Docket Number:	14-AAER-02
Project Title:	Computer, Computer Monitors, and Electronic Displays
TN #:	205825
Document Title:	ITI & Technet Comments: Re June 1st Aggios Submission
Description:	Comments on Aggios' Desktop Computer Study
Filer:	System
Organization:	Information Technology Industry Council/Chris Hankin
Submitter Role:	Public
Submission Date:	8/25/2015 12:58:52 PM
Docketed Date:	8/25/2015

ITI & Technet Comments: Re June 1st Aggios Submission

CEC Draft Computer Standards (Docket #14-AAER-2)

ITI/TechNet Comments on Aggios' Desktop Computer Study
Date: August 25, 2015

Hard Drive (HDD) Spin Down Time

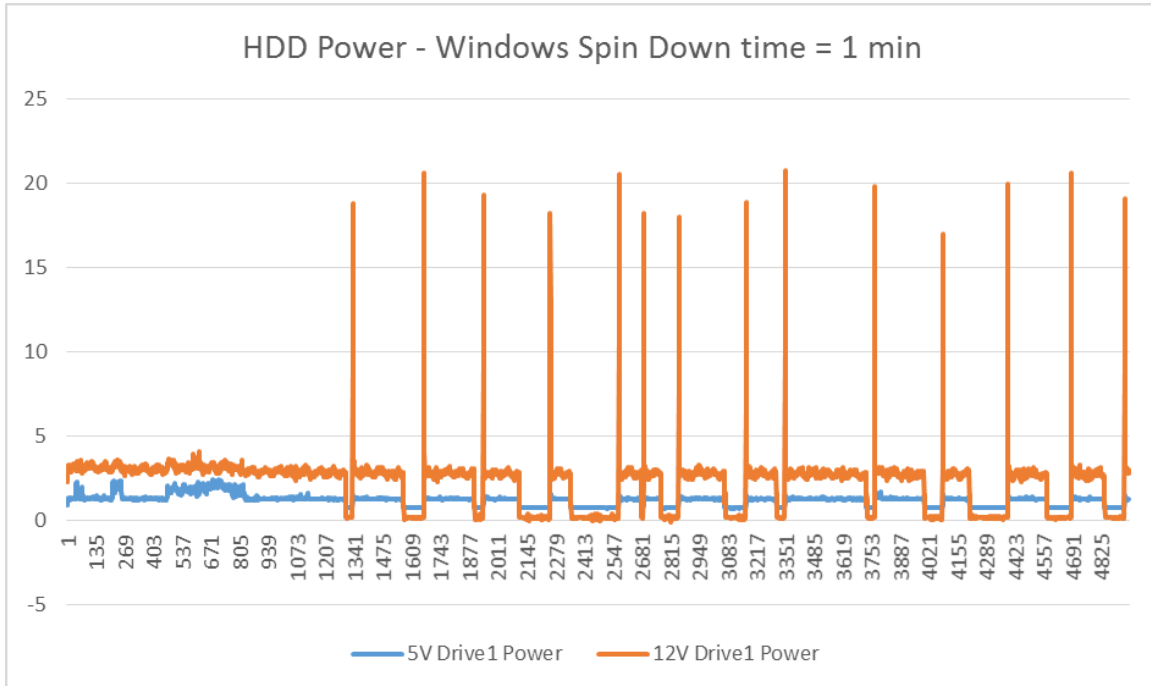
The industry representatives at the June 9-10 meeting went into great detail about how just using Windows hard drive spin down time set to 1 minute is not a “free” power adder.

There is another issue that needs to be brought up, and that is about hard drive spin down time set to 1 minute of inactivity inside Windows. How often will the hard drive have to spin back up because the system needs to access information on the hard drive and how much energy does that consume?

The data below shows a Western Digital Blue 1TB hard drive that in Windows had the hard drive spin down time set to 1 minute. This shows what happens when Windows is set to do the spin down on a real system sitting at Idle for 80 minutes. This is an aged operating system, not a fresh install, so most of the activities of a new operating system have already happened. This is the Windows operating system working in a normal condition just like the average user would observe.

It takes around 20 minutes before the hard drive spins down for the first time. The ENERGY STAR* - Computers Ver 6.1 test procedure does allow HDD to spin down but in correct testing the HDD can't be counted on spinning down because testing has to stop at 20-25 minutes. Also notice that once the HDD does spin down it doesn't stay off very long. This is in fact what happens during normal conditions in a Windows* operating system.

- Power of the hard drive before it spins down.
- Average power of the hard drive over the 60 minutes where the hard drive is spinning down and back up.
- Notice the spin up power and how often the hard drive does spin up.
- The average time the hard drive stays in the Spin Down mode during this testing is 92 seconds.

as what Aggios reported. This is all the reasons why this setting is not used by the industry (hard drive reliability, latency, and added cost adder to users to overcome latency) and another solution needs to be investigated for hard drive power savings.

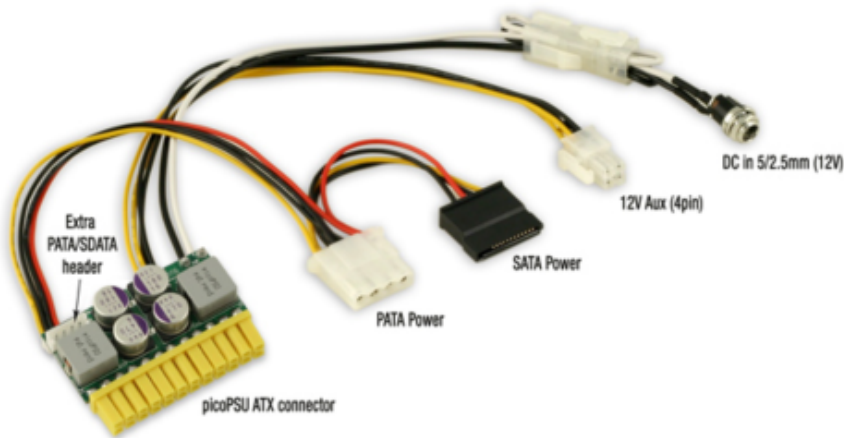
The Pico Power Supply used for the Aggios study is not on either one of these lists. The Industry strongly question any data for any components that don't meet industry standards or are not listed on a good tested list.

There are reviews about this power supply dating back to 2006 (<http://www.silentpcreview.com/article601-page1.html>). This kind of Pico PSU has been around for that long and still is not used widely in the industry where everyone is looking for any advantage over the competition, because it is not an adequate power supply.
